BID NO. 2024-25.10
WILSON HIGH SCHOOL: MEDIA CENTER UPGRADE
February 11, 2025
ADDENDUM NO.01

ADDENDUM 01 Details

**WILSON HIGH SCHOOL
MEDIA CENTER REMODEL
HACIENDA LA PUENTE UNIFIED SCHOOL DISTRICT**

tBP Project No. 21211.00

drawing no.:
A-0

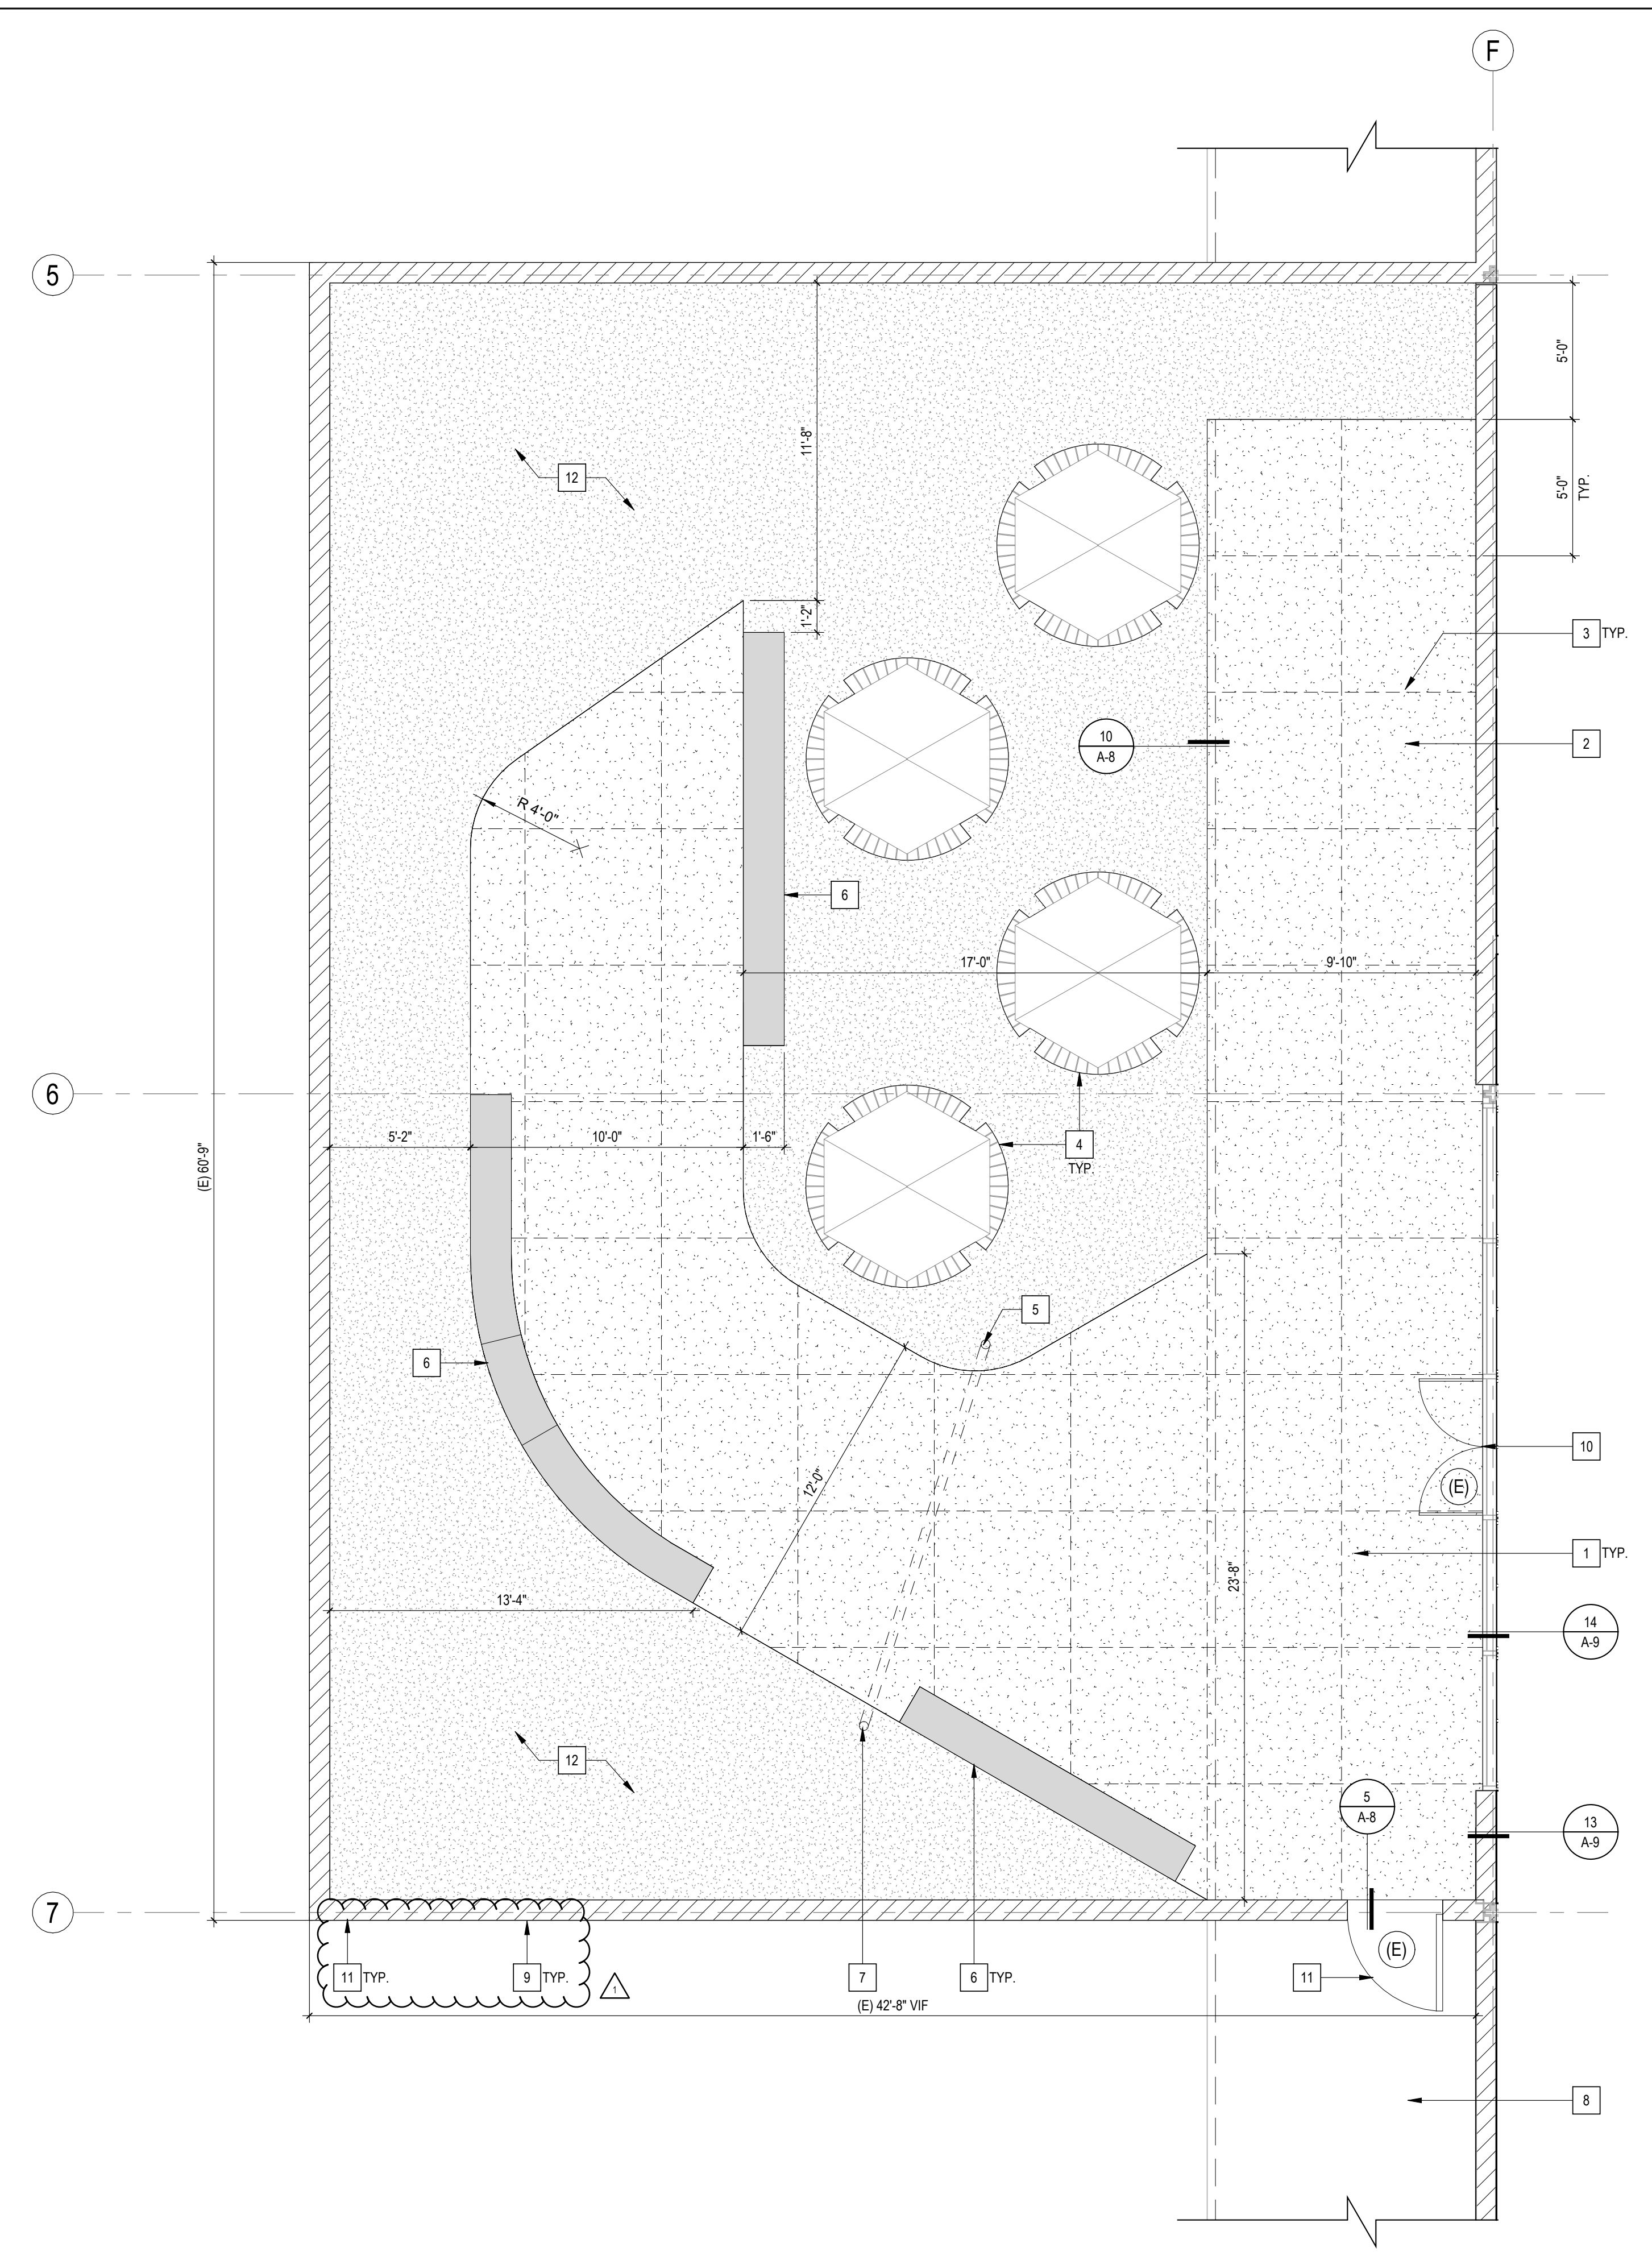
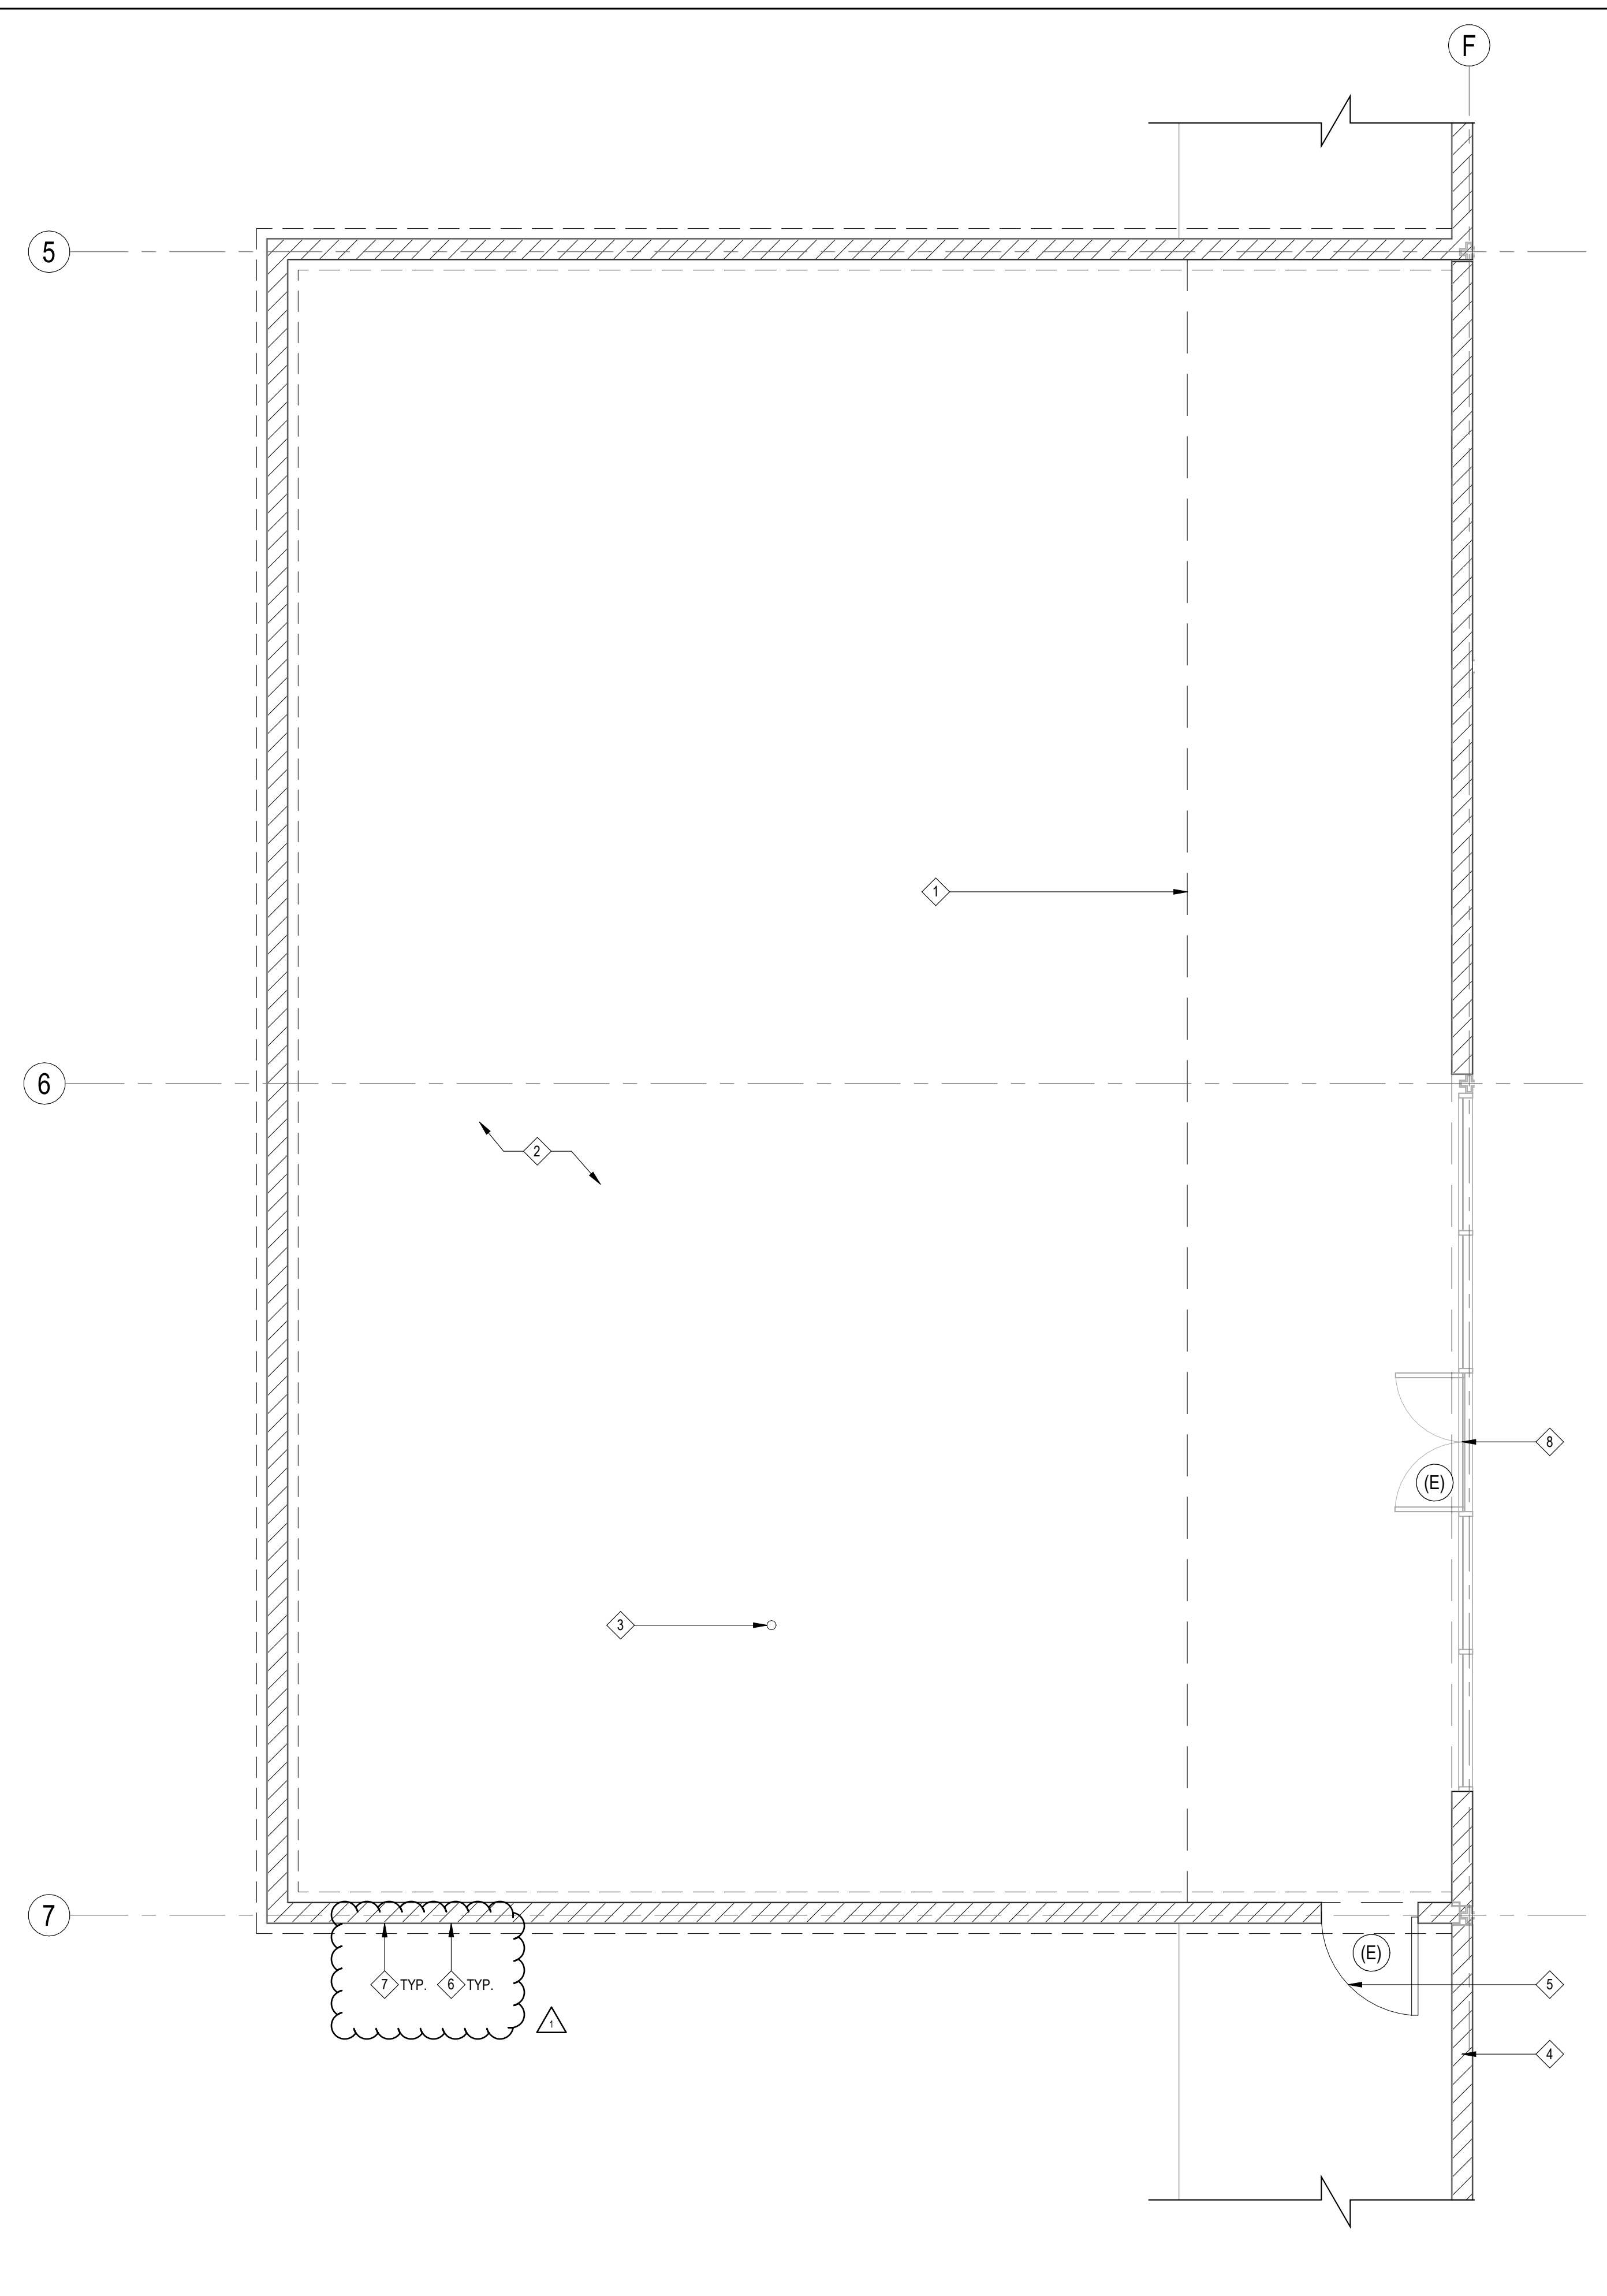
1. SHEET A-0 SITE DEMO AND REMODEL PLAN
 - a. Site Demo Plan - Revised demolition Keynote #7 to add the height of the existing brick wall for Bid Alt # 1.
 - b. Site Demo Plan - Revised Keynotes #6 and #7 have been labeled as "Typical" on the Site Demo Plan.
 - c. Site Plan - Keynotes # 9 and #11 have been labeled as "Typical" on the Site Plan.
 - d. Replace Sheet A-0 Site Demo and Remodel plan in its entirety issued with this addendum.
2. SHEET A-7 INTERIOR ELEVATIONS
 - a. Remodel Keynote # 10 was modified to include a projection screen mounting detail 20/A-9 and revise mounting height to
 - b. Replace Sheet A-7 Interior Elevation sheet in its entirety issued with this addendum.
3. SHEET A-9 INTERIOR DETAILS
 - a. Added Detail 20 /A-9 for the mounting of the motorized projection screen.
 - b. Replace Sheet A-9 Interior Detail sheet in its entirety issued with this addendum.

Is the entire brick wall around the outdoor area to be removed (as an alt) or only the south wall with the rest remaining? Is the fence alt to replace the North, South, and West walls with fence, terminating at the building along the East perimeter?

Response – Bid Alternate No.1 indicates the removal the entire masonry wall and foundation and replace it with new foundation and fencing and shall be excluded from the base bid and listed separately. Demolition keynote #7 “Bid Alt No.1” has been modified to indicate the wall height and is noted as typical for all sides of the masonry wall, and keynote #6 is noted as typical for all sides of the masonry wall. Site Plan keynote #11 “Bid Alt No. 1” and keynote #9 is typical for all sides of the masonry wall. Plan A-0 is attached to this addendum.

A-7

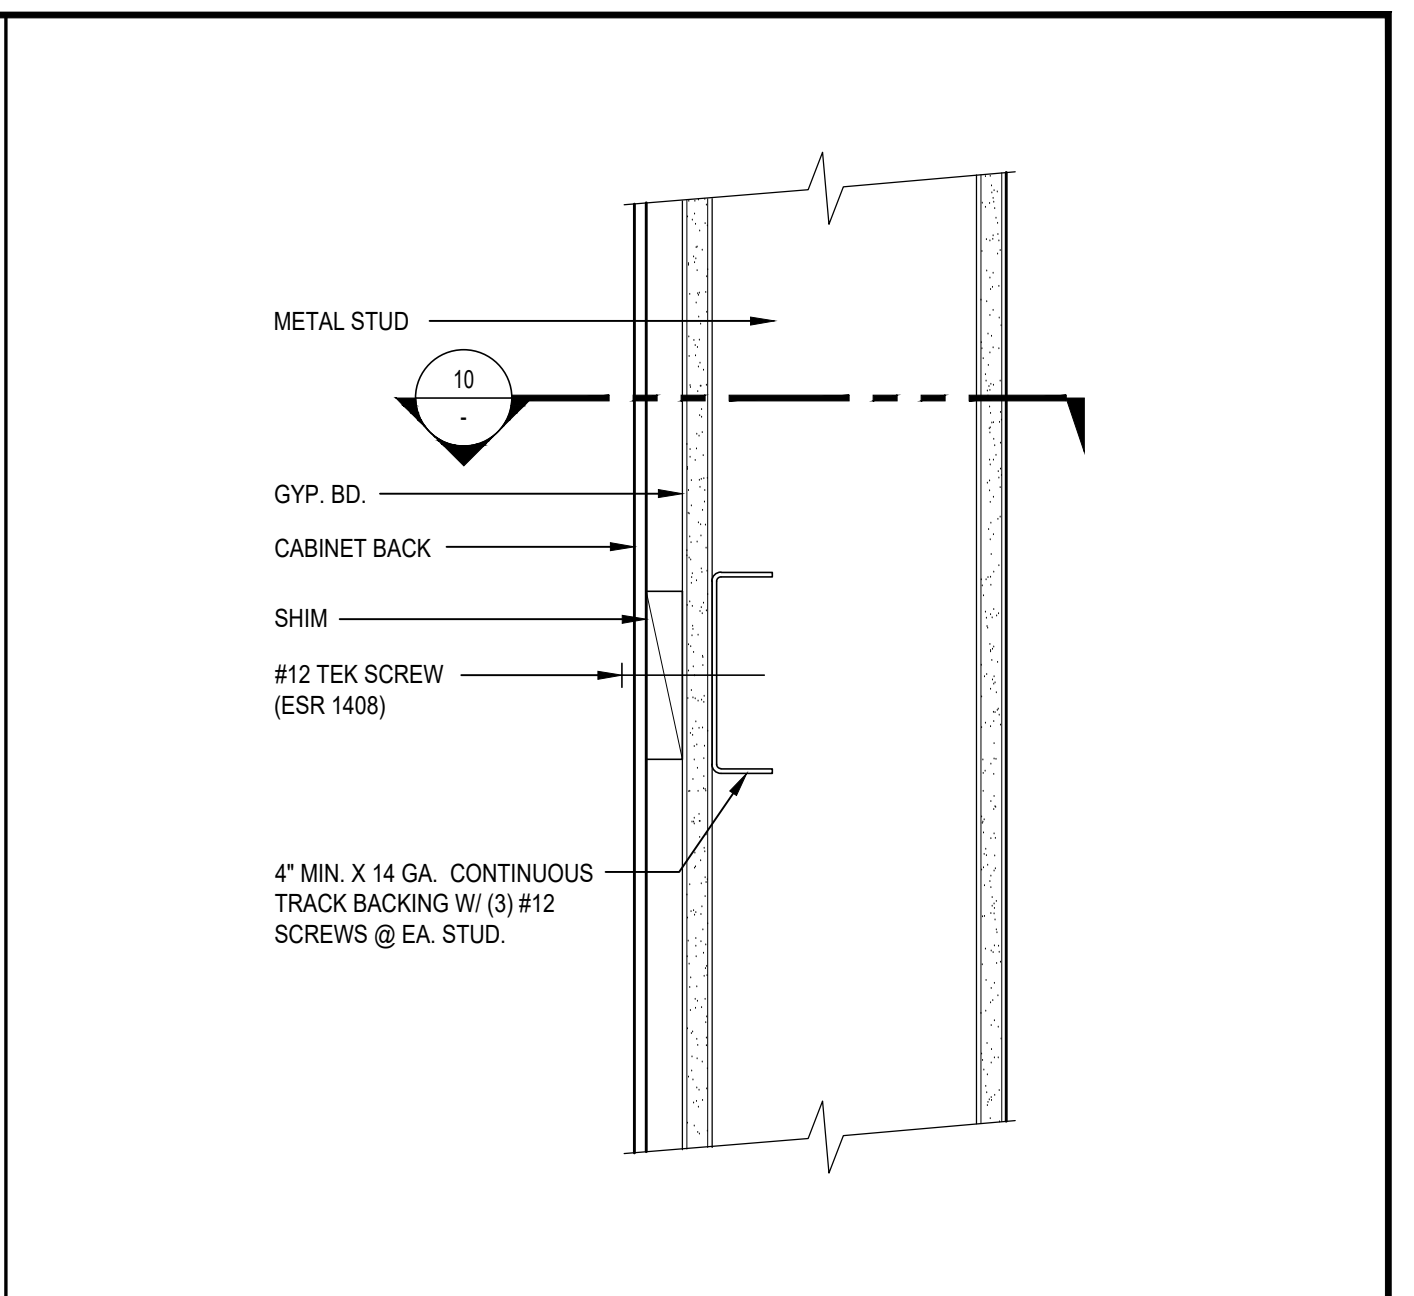
Please clarify the mounting details for the projection screens. Keynote #10 on sheet A-7 says to use 8/A-9 however that detail is for a motorized window shade. Please clarify and provide an updated detail.

Response – New projection screen mounting detail 20/A9 is provided for mounting of the screen. Plan A-7 and A-9 are attached to this addendum.
